Village Square
Residential and Commercial Development
3095 Albany Post Road
Village of Buchanan, NY

Project: Village Square – Buchanan, NY
Scope: Response to Comments of David B. Smith of July 26, 2023
Village Planning Advisor
Date: August 8, 2023
By: Ralph G. Mastromonaco, PE

Project: Village Square – Buchanan, NY
Scope: Response to Comments of NYS DEC of April 12, 2023
Date: August 7, 2023
By: Ralph G. Mastromonaco, PE

Jeff Faiella, Chairman and Members
Village of Buchanan Planning Board
Municipal Building
236 Tate Avenue
Buchanan, NY 10511

DRAIN/SEWER/WATER SEPARATION N.T.S.

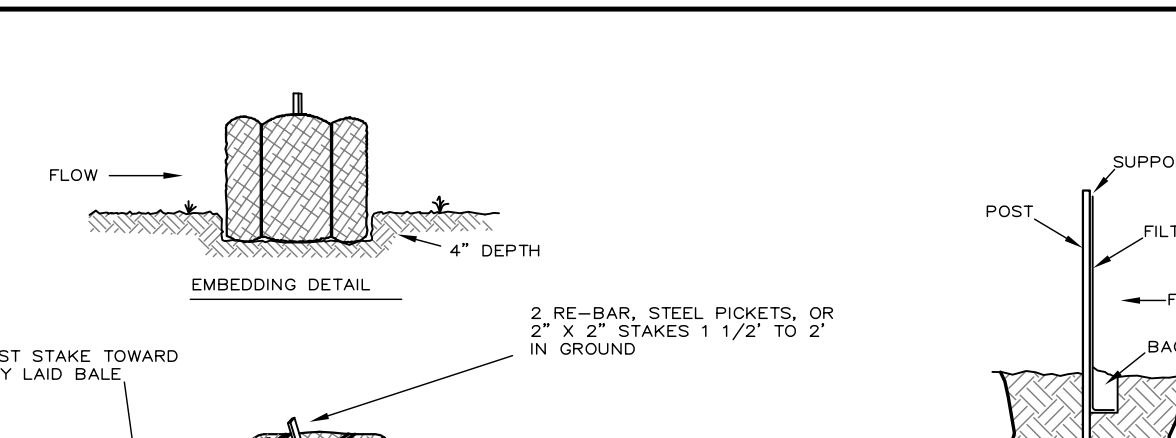
21. A catch basin is proposed over the existing sewer main; this should be revised. If possible, ten feet of separation should be provided between the sewer main and drainage pipes or structures.

Response: This has been addressed.
